U.S. NUCLEAR REGULATORY COMMISSION
REGION I

Report No. 50-423/85-54

Facility Name: Millstone Nuclear Power Station, Unit 3

Inspection Summary: Inspection during September 9-20, 1985 (Report 50-423/85-54)

Calculation for Verification of Control Room Pressurization System

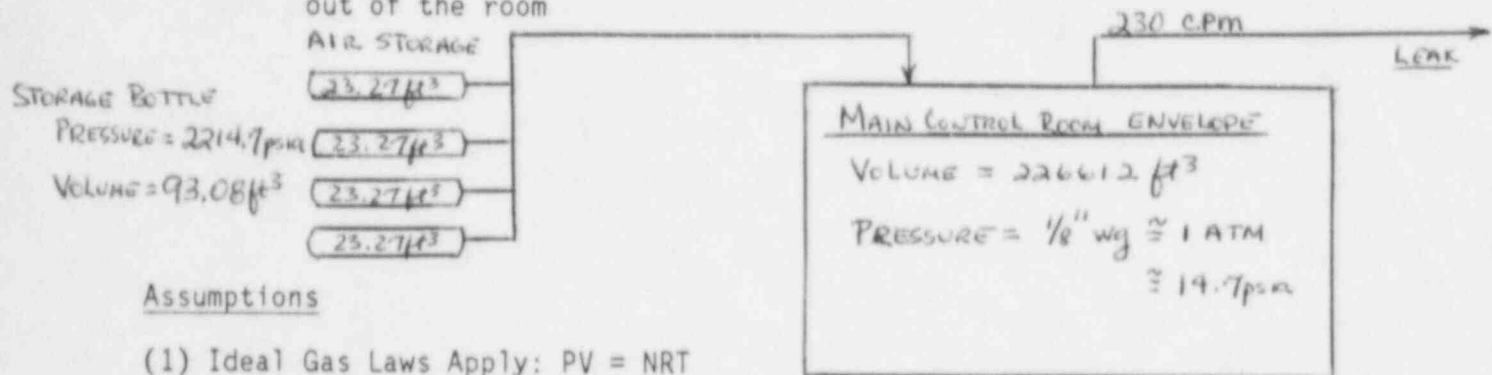
The results of the calculation did not clearly demonstrate that the four air bottle train could perform the system's intended function; therefore full redundancy between the two subsystems was not shown. The inspector then requested and reviewed SWEC calculation P(B)-0990, revision D, which considered the capability of the redundant system train. The results of P(B)-0990 indicated that 4 air bottles were sufficient to handle 54 minutes of outleakage from the control room.

The inspector discussed the results of the above calculations with representatives of SWEC and the licensee. The inspector was informed by SWEC that the control room leak rate was currently projected to be on the

order of 120 cfm (instead of 230 cfm) based on additional analysis. With this lower leak rate, the four bottle train would be expected to provide more than 60 minutes of service. Further, the licensee informed the inspector that the results of an actual leak rate measurement which would be performed during the preoperational test program would serve as the basis for judging the adequacy of the system design.

In response to the concerns the inspector identified in this area, the licensee also provided an internal memorandum dated September 19, 1985 which indicated that the 230 cfm leak rate specification was no longer applicable and had been removed from the FSAR prior to revision 13. The inspector commented that the NRC SER still mentioned the 230 cfm limit and that the licensee should clarify the need for a leak rate limit with NRR.

The inspector informed the licensee that the adequacy of the design of the control room pressurization system would be considered unresolved pending: (1) clarification by the licensee of the control room envelope's design leak rate requirement and agreement from NRR in this leak rate; (2) the licensee's completion of the control room envelope leak rate test; and, (3) the licensee's subsequent analysis of the actual leak rate to verify system operability. (50-423/85-54-02)
